LTB00814NAS6

TECHNICAL BULLETIN

Under Hood Lower NVH Pads/Dirty Air Duct Guides Freezing

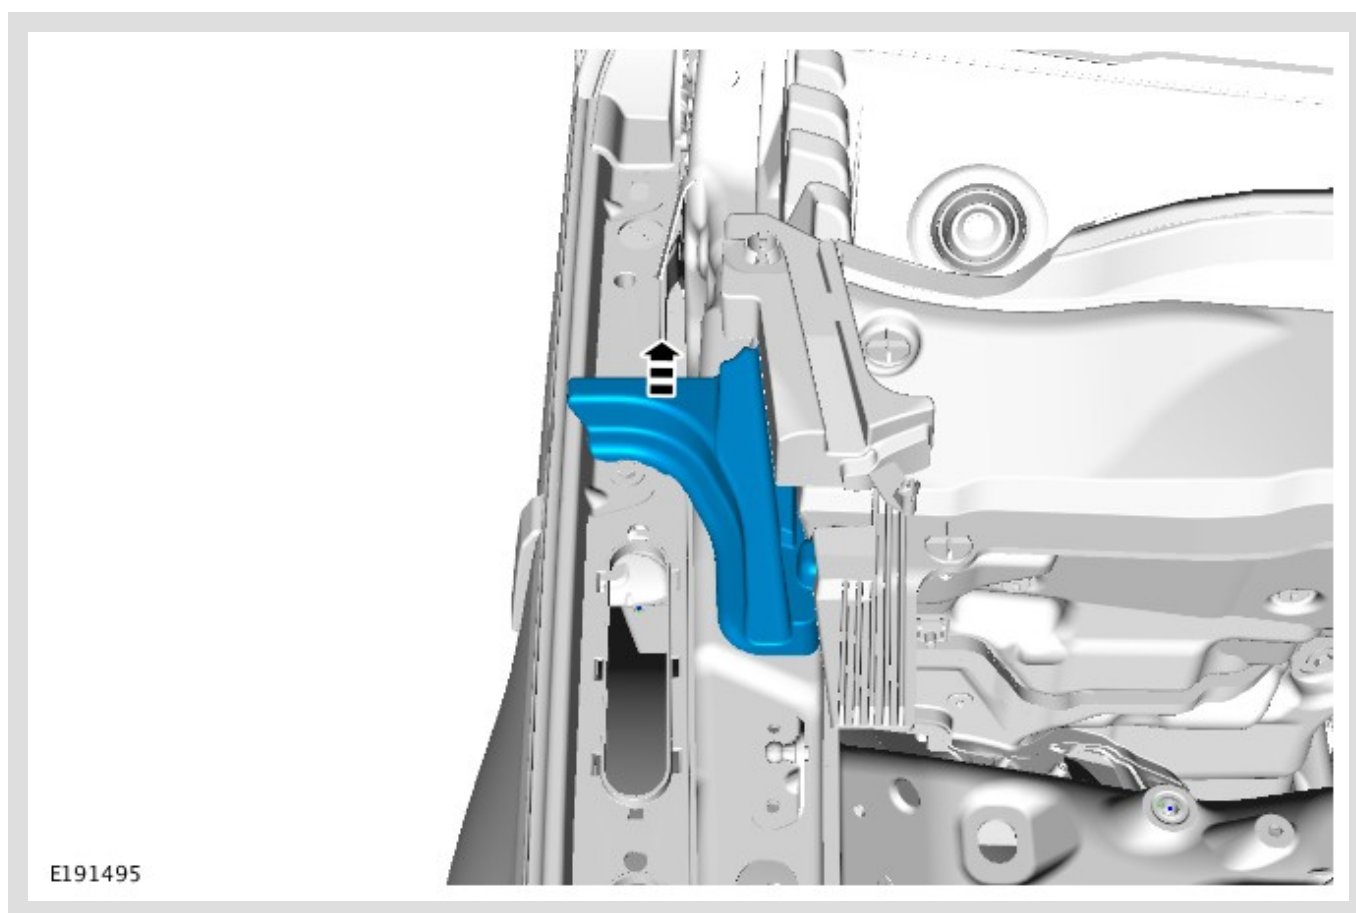
- Perform this step to both sides of the vehicle.
- Right-hand shown; left-hand similar.

Remove and discard the under hood lower right-hand Noise Vibration Harshness (NVH) pad.

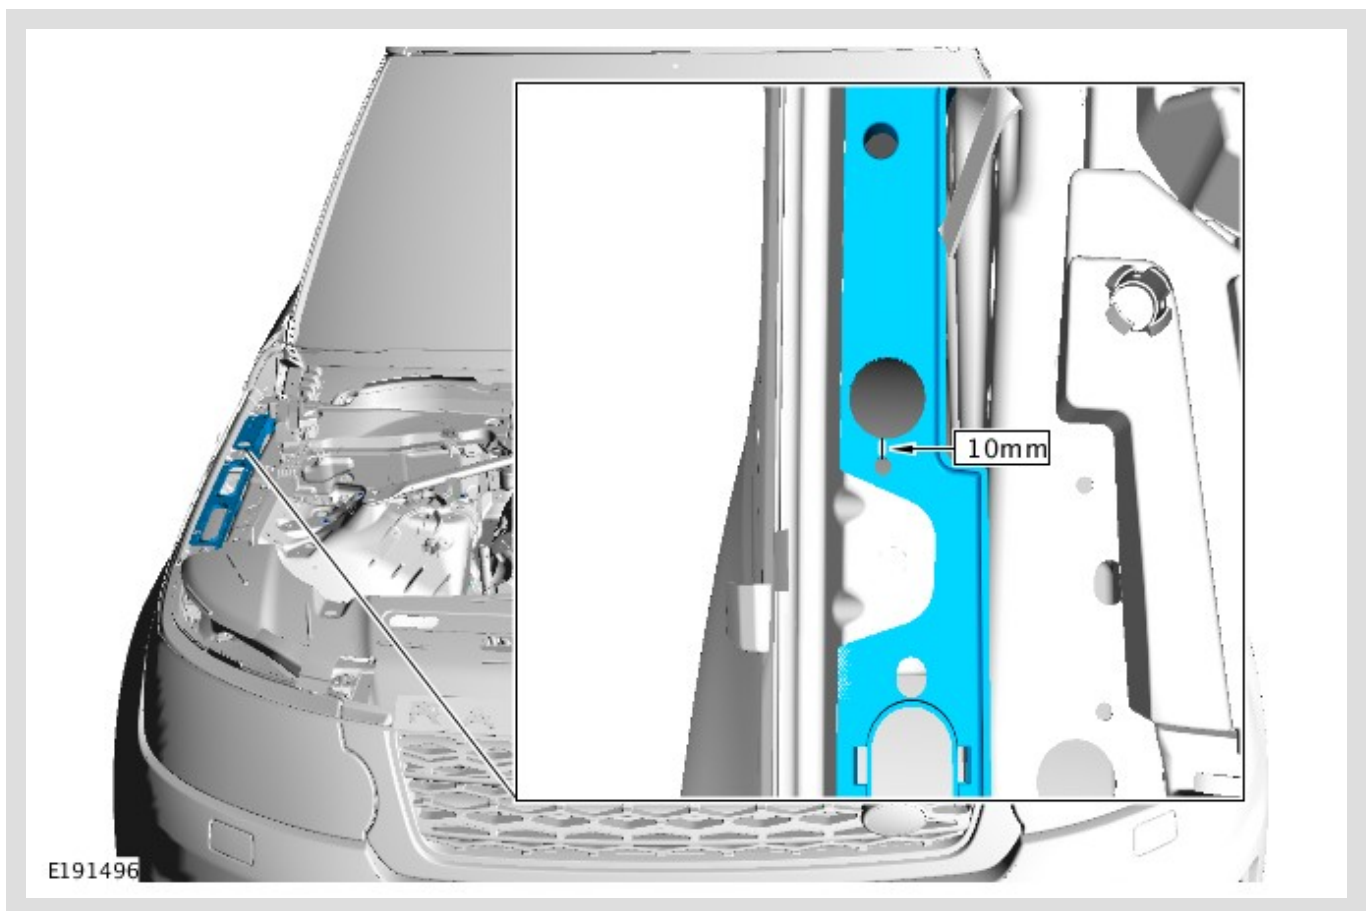
- To avoid cross-contamination (galvanic corrosion), this Step must be performed using either a new, unused drill bit or an aluminum-repair-only drill bit.
- A Zinc-rich primer must be applied to any bare metal surfaces after drilling.

- Perform this step to both sides of the vehicle.
- Cleanliness is important to avoid galvanic corrosion.
- Make sure any swarf is removed/cleaned away.

Drill a new 6.5 mm diameter hole as shown.

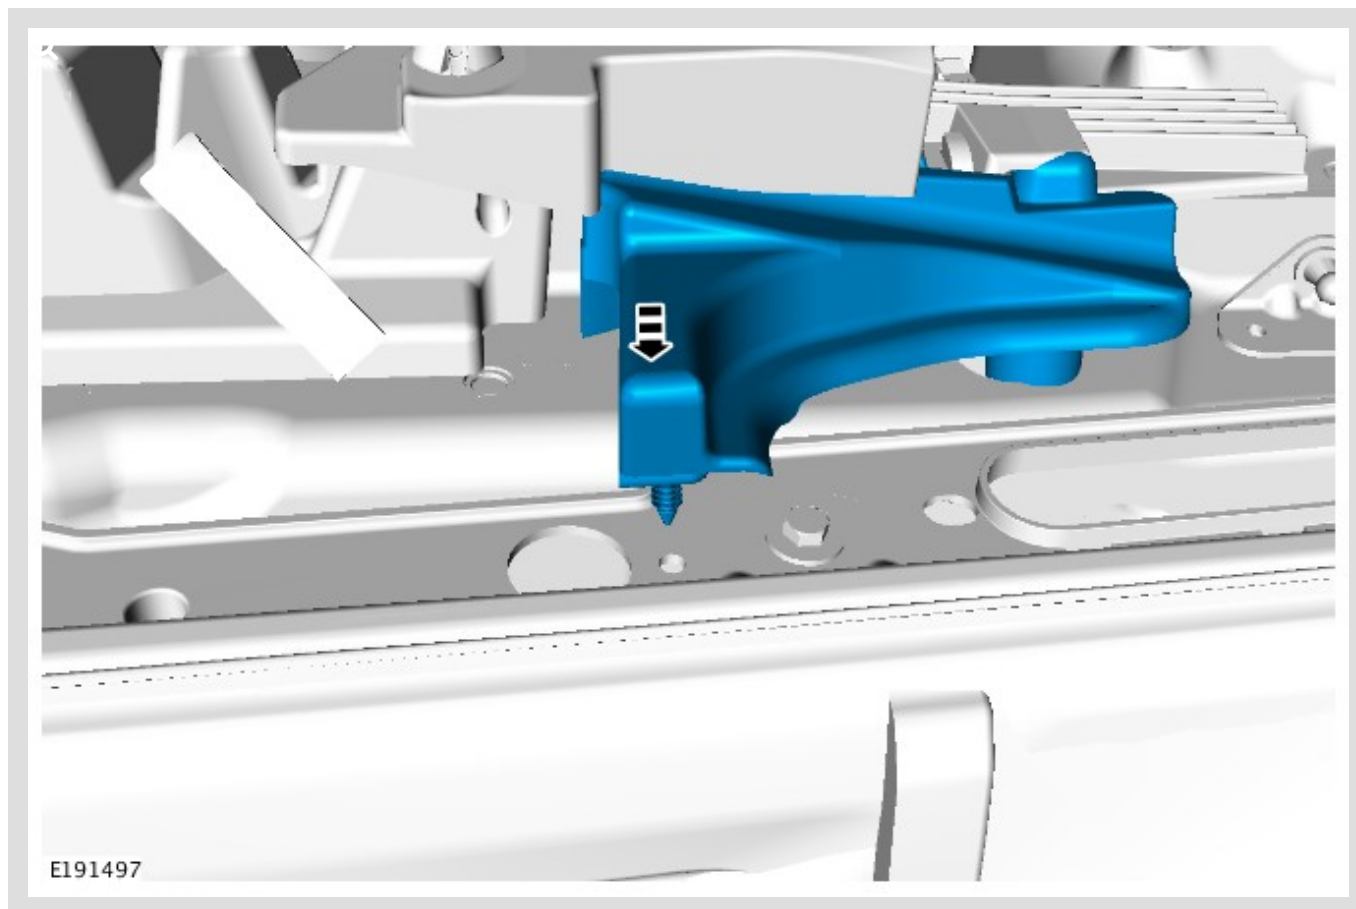
- Perform this step to both sides of the vehicle.
- Right-hand shown; left-hand similar.

Install the new under hood lower NVH pad.
